DESIGN DS	DRAWN BY MB	DART AEROSPACE LTD HAWKESBURY, ONTARIO, CANADA	
CHECKED <i>[Signature]</i>	APPROVED <i>[Signature]</i>	DRAWING NO. DSI 9310	REV. A SHEET 1 OF 1
DATE 05.09.13		TITLE COMPATIBILITY WITH GENEVA CONSOLE	SCALE 1:2
A	05.09.13	NEW ISSUE

DART SERVICE INSTRUCTION

TO AMEND INSTALLATION DRAWING D350-616 REV. B
REF. CANADIAN STC SH96-10 ISSUE 2
FAA STC SR00405NY

D3179-041 FWD LITTER TIE DOWN

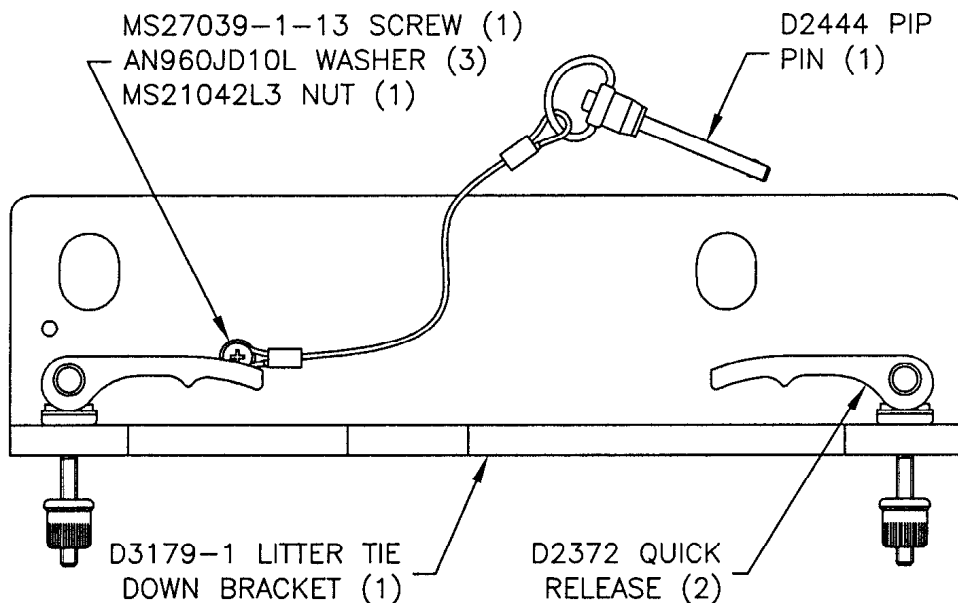
FWD LITTER TIE DOWN BRACKET D3179-041 CAN BE USED IN LIEU OF D2350 LITTER TIE DOWN BRACKET REFERRED TO IN THE PARTS LIST FOR COMPATIBILITY WITH THE GENEVA CONSOLE. TO ASSEMBLE D3179-041, ORDER D3179-1 FROM DART AND TRANSFER HARDWARE FROM D2350 AS SHOWN BELOW. IT IS ACCEPTABLE TO TRIM D3179-1 AS REQUIRED FOR FIT AS LONG AS A MINIMUM EDGE DISTANCE OF 0.250" IS MAINTAINED FROM THE EDGE OF ALL HOLES AND SLOTS. PRIME AND PAINT IN ACCORDANCE WITH THE AIRCRAFT MAINTENANCE MANUAL PRIOR TO FINAL INSTALL.
